ADDENDUM 01

Date: April 24, 2026

Project: RFB-458 Fairmont State University Musick Library Modernization

NEW WORK - POWER RISER DIAGRAM
N.T.S.

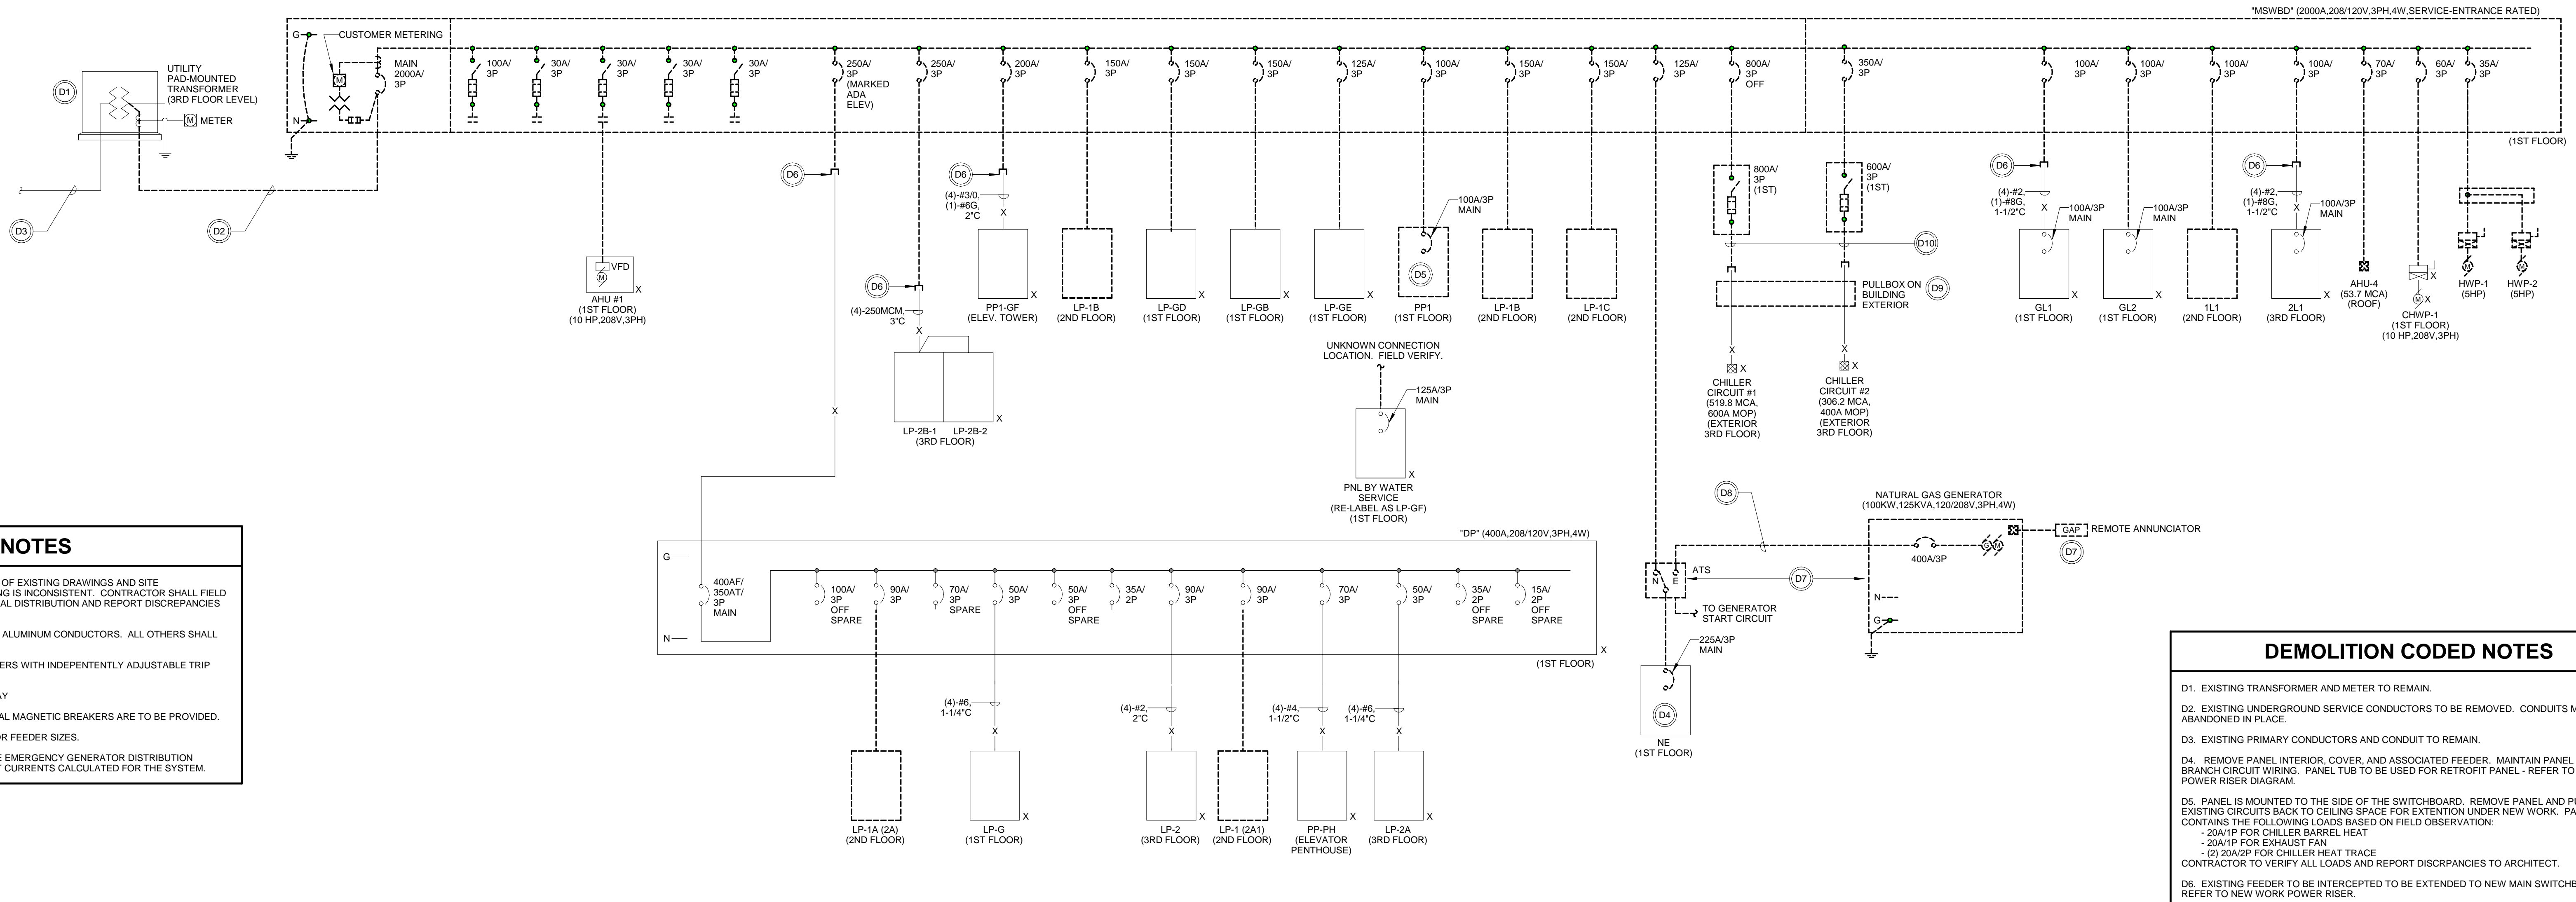
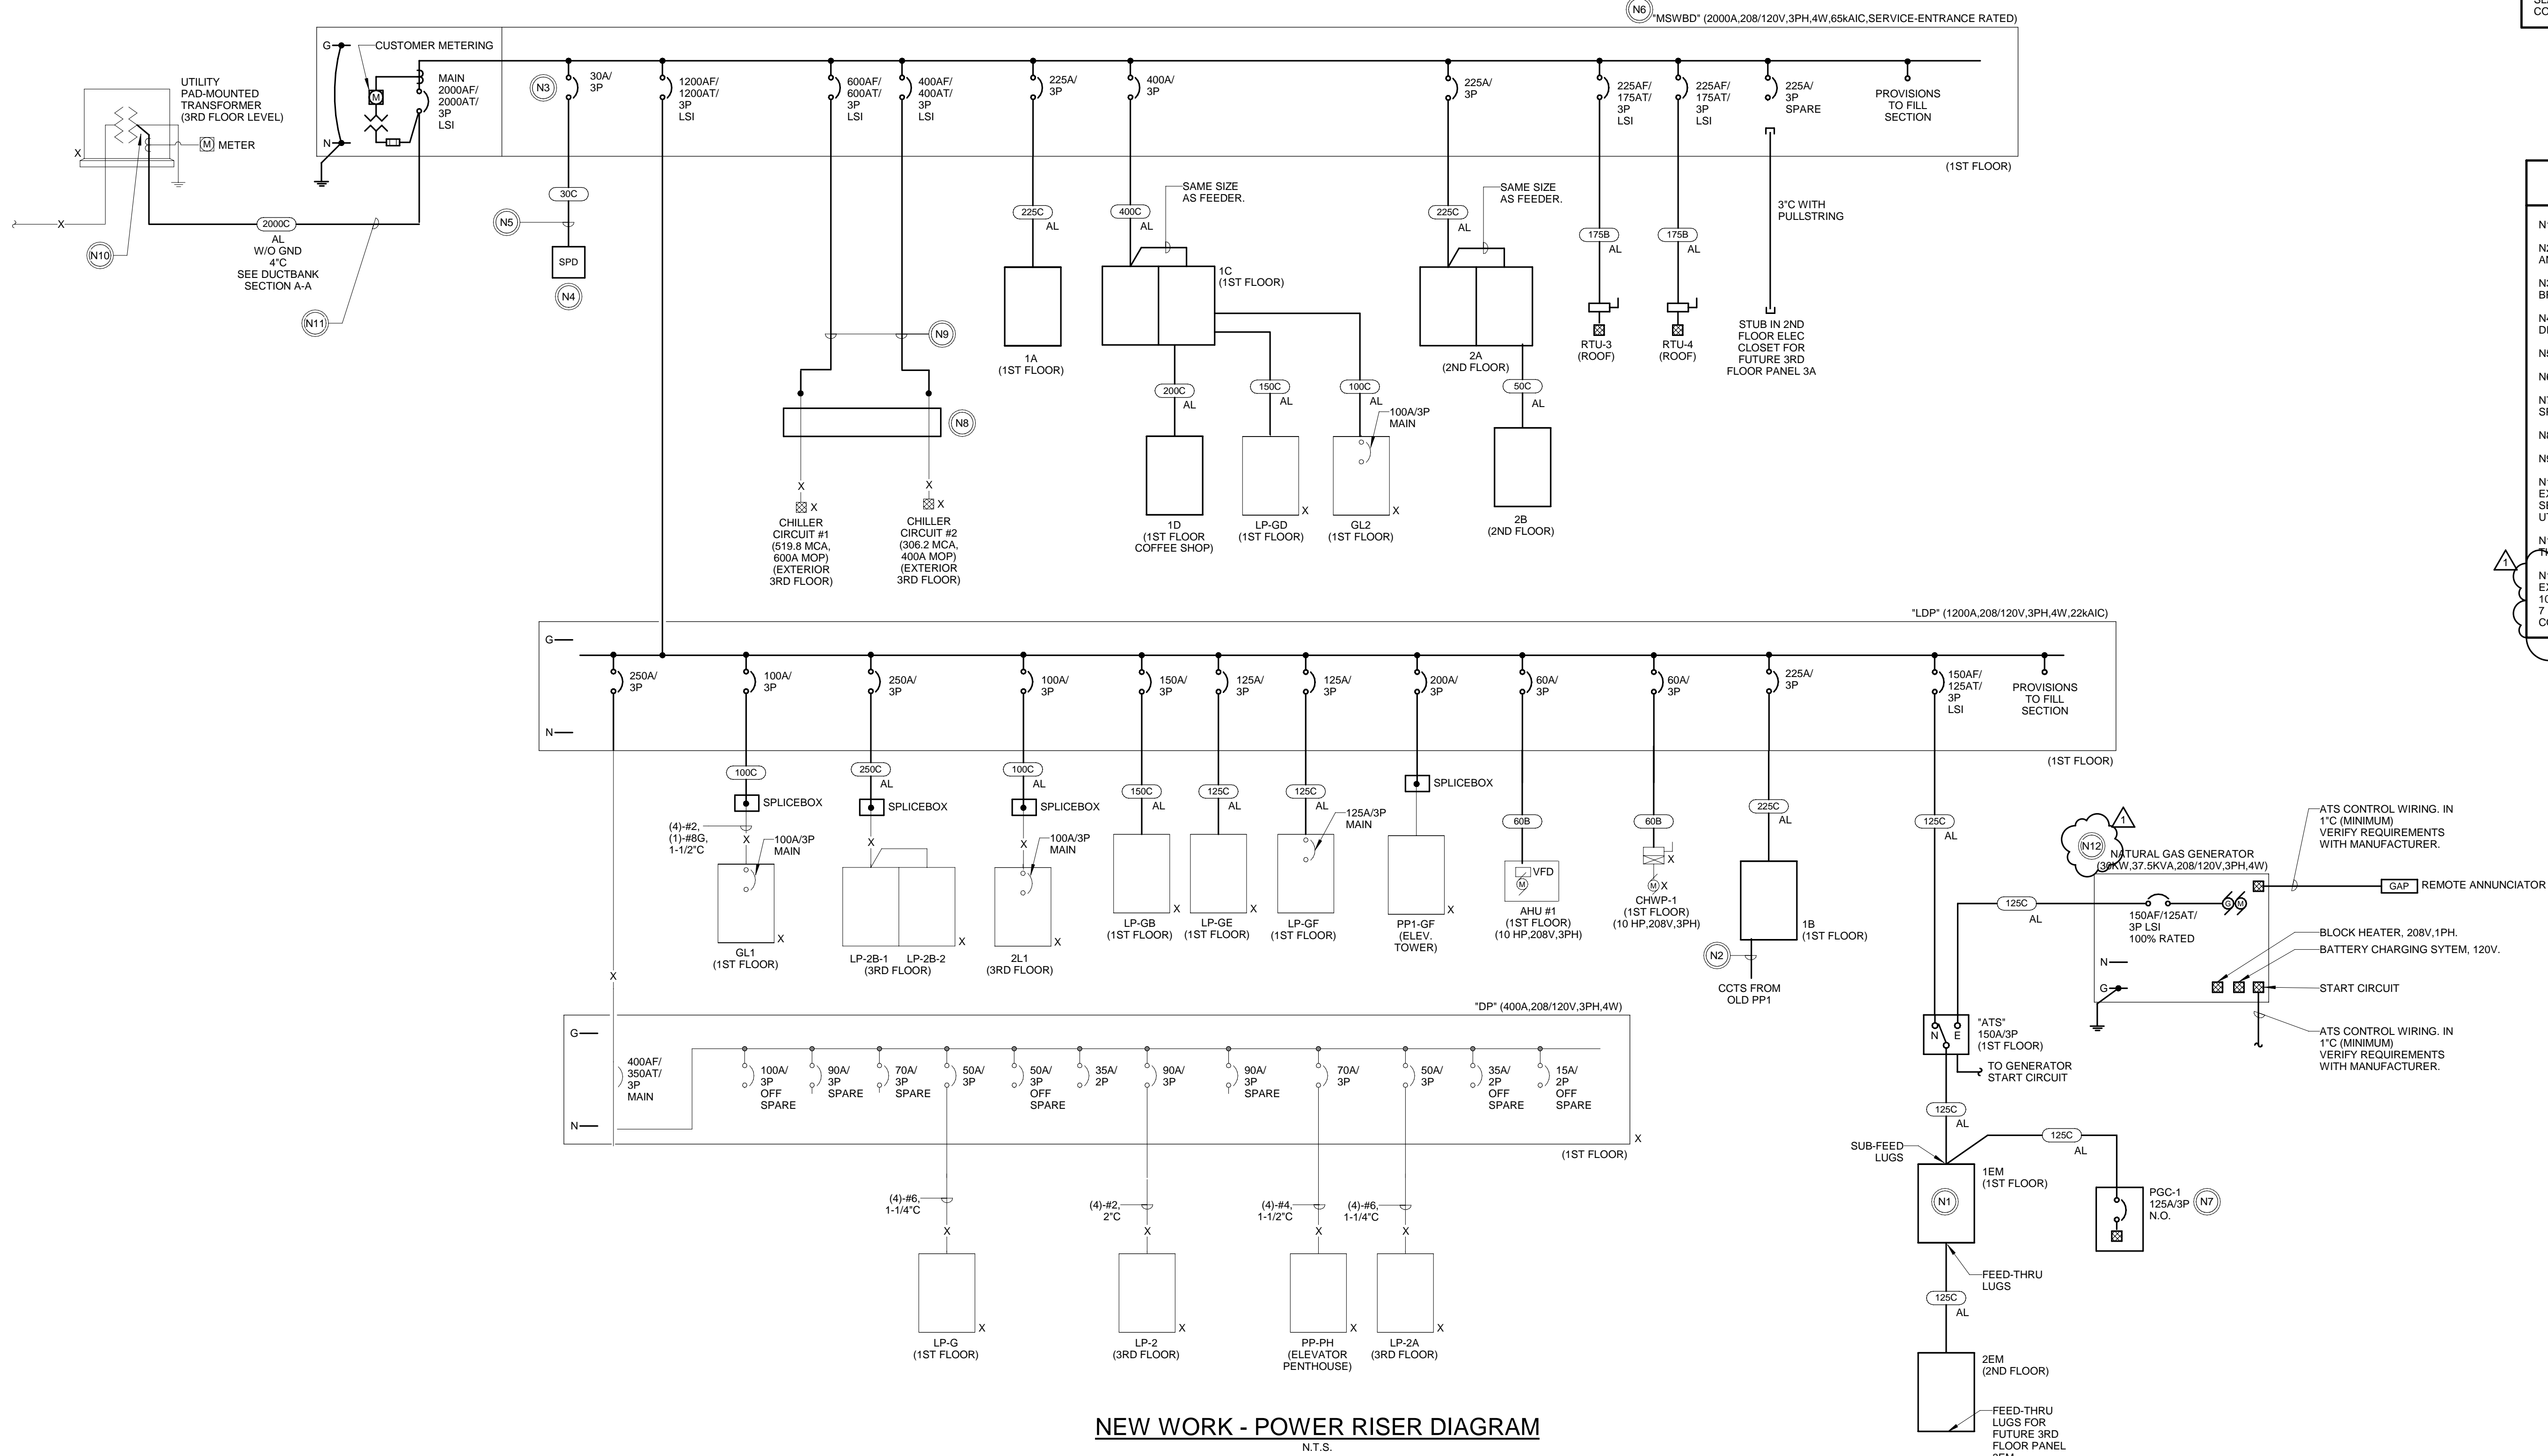
- a. Added a note to provide an extended exhaust flue on the generator.
7. Sheet T0.1 NOTES & LEGENDS – TECHNOLOGY
 - a. Revised Electrical / Technology Division of Scope.
